# Recall Campaign

**6172**

## INTERCOOLER SLEEVE METAL BAND

### Replacement of band fixing sleeve to throttle body

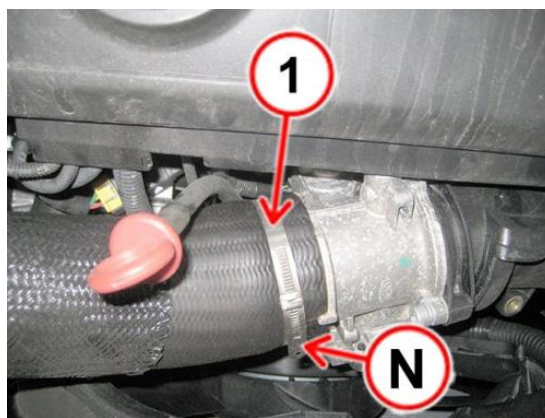
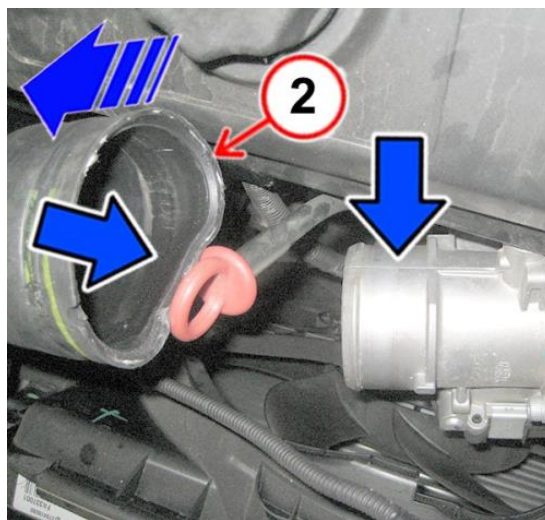
- Remove the band (1) fixing the sleeve to the throttle body.

*Take care not to damage the sleeve. It is advisable to use a side cutter pliers or other suitable tool to wrap metal tape on the free terminal (N) until it breaks. Operate in this way to avoid contact with the sleeve.*

- Then pull out the sleeve (2) from the throttle body.
- Using moist tissues or a cloth, carefully clean both the inner end part of the sleeve and the coupling housing on the throttle body.

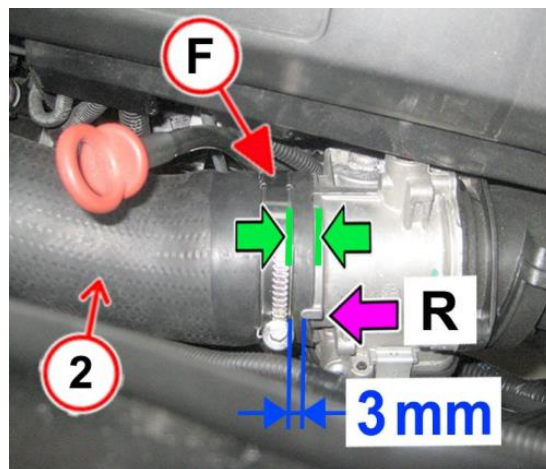
- Insert a new fixing collar (F), to be taken from Spare Parts, onto the sleeve (2) in the position shown (with fastening screw facing towards the radiator).
- Reconnect the sleeve to the throttle body, being very careful to position it correctly abutting on the indicated alignment notch (R) shown.
- Make sure that the collar (F) is perfectly parallel to the abutting edge of the throttle body at a distance of 3 mm from the end of the notch (R), as shown.
- Close the collar without tightening holding it in position.

- Using a torque wrench and extension - single stretch of approximately 20 cm - tighten at a torque of 5 -0 / +0.3 Nm.
- After tightening, apply a spot of white paint on the sleeve or on the throttle body to indicate that the collar has been replaced.

## A/C system pipe retaining clip application

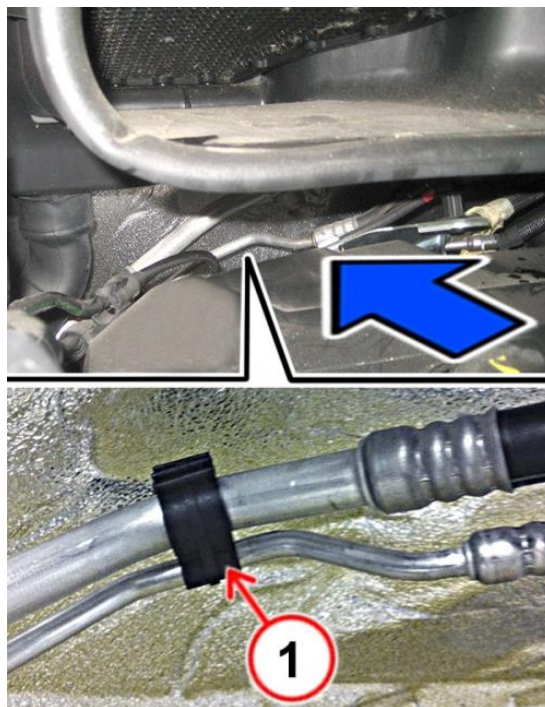
- Operating on the rigid supply and return pipes of the evaporator, in the illustrated engine compartment zone, apply a retaining clip (1) in the points shown in detail to prevent contact.
